Uninterruptible Power System Units and Valve-regulated Sealed Type Lead Acid Batteries

ID:DD23-17

Amended-Original Requirements Comparison Table
(Uninterruptible Power System Units and Valve-regulated Sealed Type Lead Acid Batteries)

Amended	Remarks
<p align="center">Fig. 1 Double conversion topology UPS unit</p>  <hr/> <p align="center">Fig. 2 Line interactive topology UPS unit</p> 	<p>Figs. 1 to 3: Incorporating the figures of UR E21(Rev.2).</p>

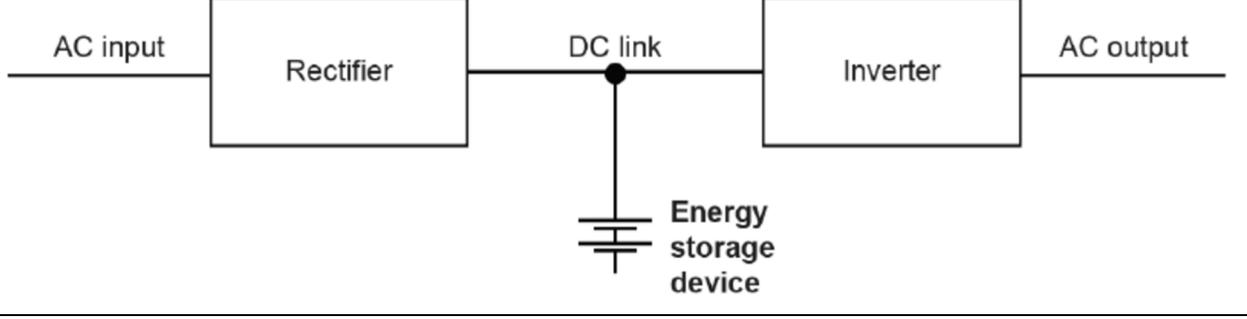
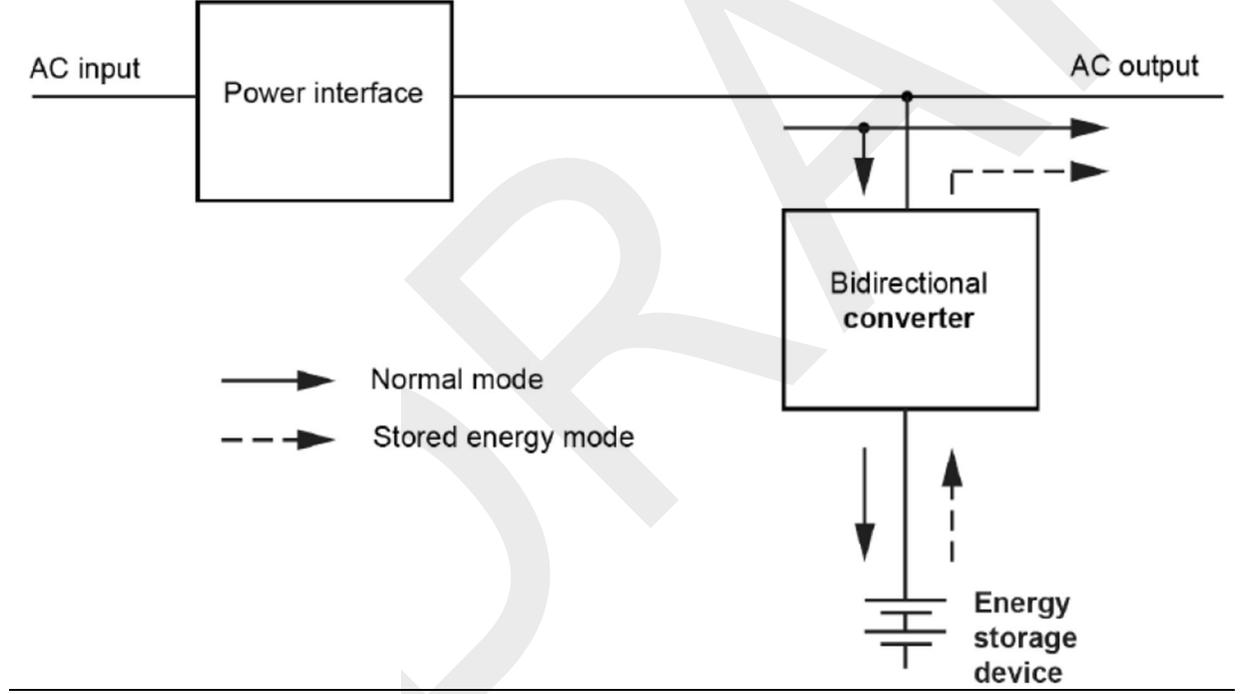
Amended	Original	Remarks
<p><u>a.c. input power failure. (IEC 62040-3:2021)</u></p> <p>(2) <u>“Double conversion topology UPS units” are those units which comprise an a.c. to d.c. converter, generally a rectifier, and a d.c. to a.c. converter, generally an inverter. In normal mode of operation, the load is continuously supplied by the rectifier/inverter combination. When the a.c. input power is out of UPS pre-set tolerances, the UPS enters stored energy mode. This topology may be referred to as “on-line UPS”. (See Annex B to IEC 62040-3:2021)</u></p> <p>(3) <u>“Line interactive topology UPS units” are those units which comprise bidirectional a.c. to d.c. power conversion, generally through a bidirectional converter and an a.c. power interface (e.g. power switches). In normal mode of operation, while the load is directly supplied with a.c. input power via the bidirectional converter, the storage device is charged through the bidirectional converter. When a.c. input power voltage is out of UPS pre-set tolerances, the UPS runs in stored energy mode. (See Annex B to IEC 62040-3:2021)</u></p> <p>(4) <u>“Standby topology UPS units” are those units which comprise a battery charger, a d.c. to a.c. converter, generally a unidirectional inverter and a UPS switch. In normal mode of operation, while the load is directly supplied with a.c. input power via the UPS switch, the storage device is charged through the battery charger. When the a.c. input power is out of UPS pre-set tolerances, the UPS operates in stored energy mode. This topology may be referred to as “off-line UPS”. (See Annex B to IEC 62040-3:2021)</u></p>	<p>input power failure.(IEC 62040-3:2011)</p> <p>(4) <u>On-line UPS units mean those systems which supply electrical power to loads via inverters without any power interruption.</u></p> <p>(3) <u>Line interactive UPS units means those systems specified in (2) above which are attached to equipment which controls voltage vibrations.</u></p> <p>(2) <u>Off-line UPS units mean those electrical power devices in which output loads are powered from bypass lines under normal operation and which are only transferred to inverters if such bypass supply falls or goes outside preset limits.</u></p>	<p>(2) In addition to the incorporation of UR E21(Rev.2), a supplementary explanation is added with reference to B.2 of IEC 62040-3.</p> <p>(3) In addition to the incorporation of UR E21(Rev.2), a supplementary explanation is added with reference to B.3 of IEC 62040-3.</p> <p>(4) In addition to the incorporation of UR E21(Rev.2), a supplementary explanation is added with reference to B.4 of IEC 62040-3.</p>
